DOMINION NUCLEAR CONNECTICUT, INC.
MILLSTONE POWER STATION UNIT 3
ASME SECTION XI INSERVICE INSPECTION PROGRAM
RELIEF REQUESTS FOR LIMITED COVERAGE EXAMINATIONS PERFORMED IN
THE THIRD 10-YEAR INSPECTION INTERVAL

RELIEF REQUEST IR-3-19
EXAMINATION CATEGORY B-A
PRESSURE RETAINING WELDS IN REACTOR VESSEL

RELIEF REQUEST IR-3-20
EXAMINATION CATEGORY B-D
FULL PENETRATION WELDED NOZZLES IN VESSELS –
INSPECTION PROGRAM B

RELIEF REQUEST IR-3-21
EXAMINATION CATEGORY C-A
PRESSURE RETAINING WELDS IN PRESSURE VESSELS

Weld ID: RHS-9-FW-2
PIPE

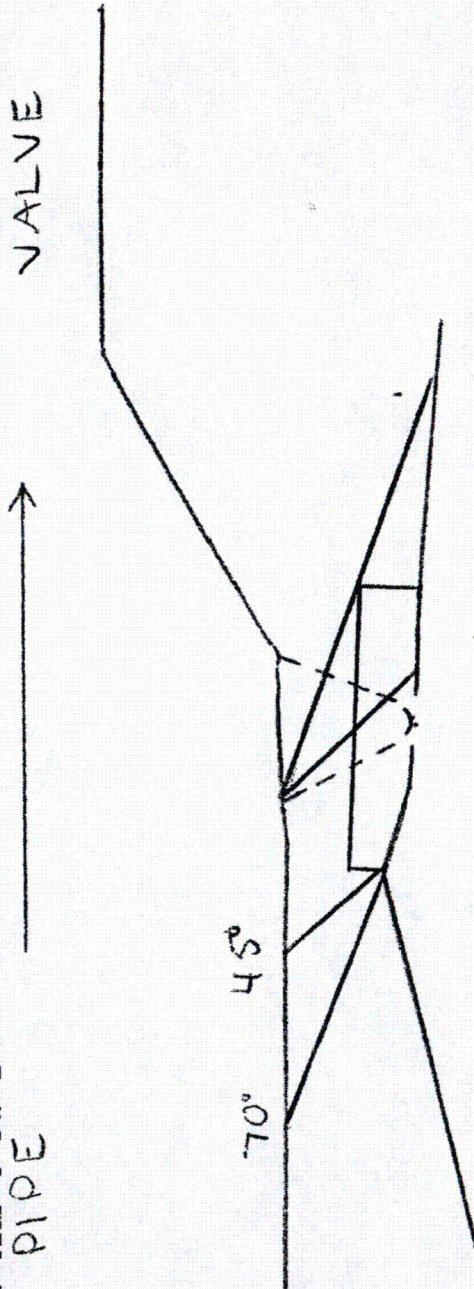
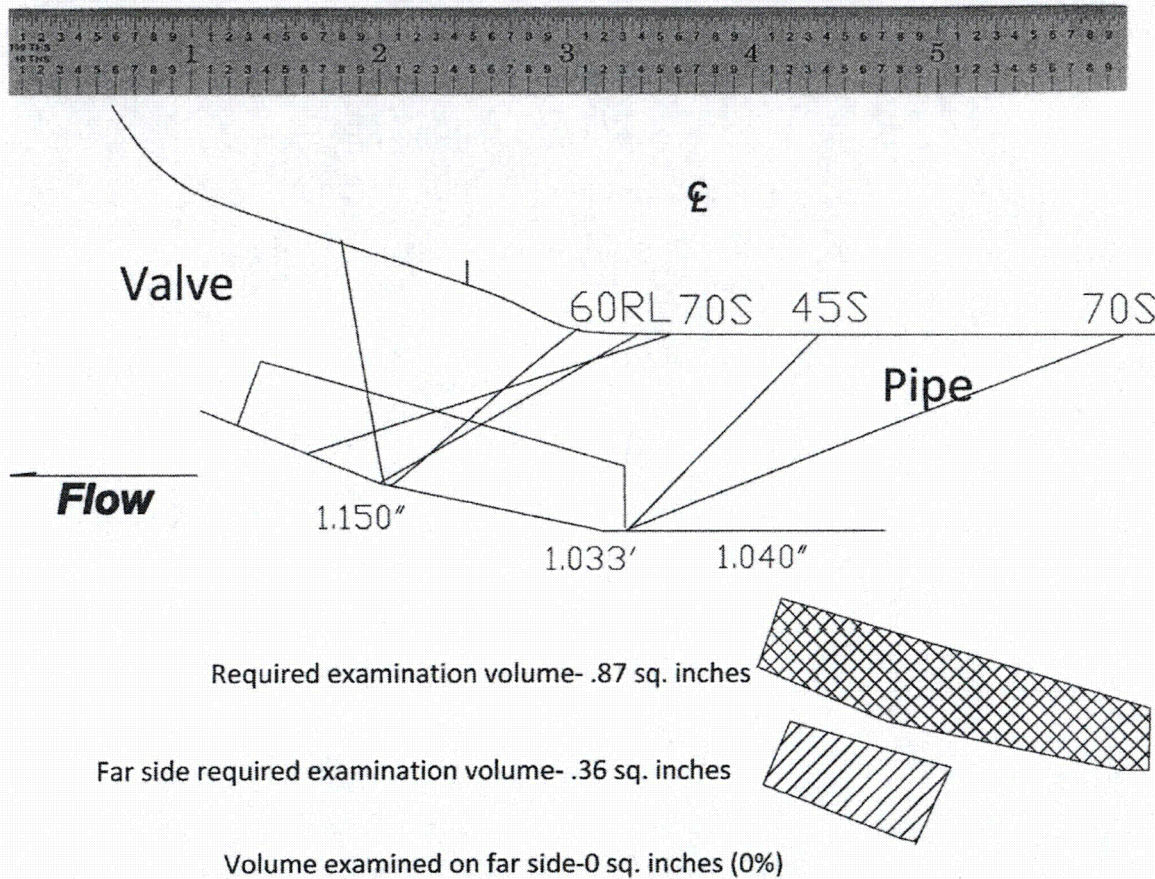
PIPE SIDE AXIAL SCAN	100%
PIPE SIDE CIRC SCAN	100%
VALVE SIDE AXIAL SCAN	0%
VALVE SIDE CIRC SCAN	0%

TOTAL COVERAGE	200% ÷ 4 = 50%
----------------	----------------

NOTE: An additional 25% total best effort (non-code) coverage was obtained for the valve side axial scan using a 70 degree shear wave search unit.
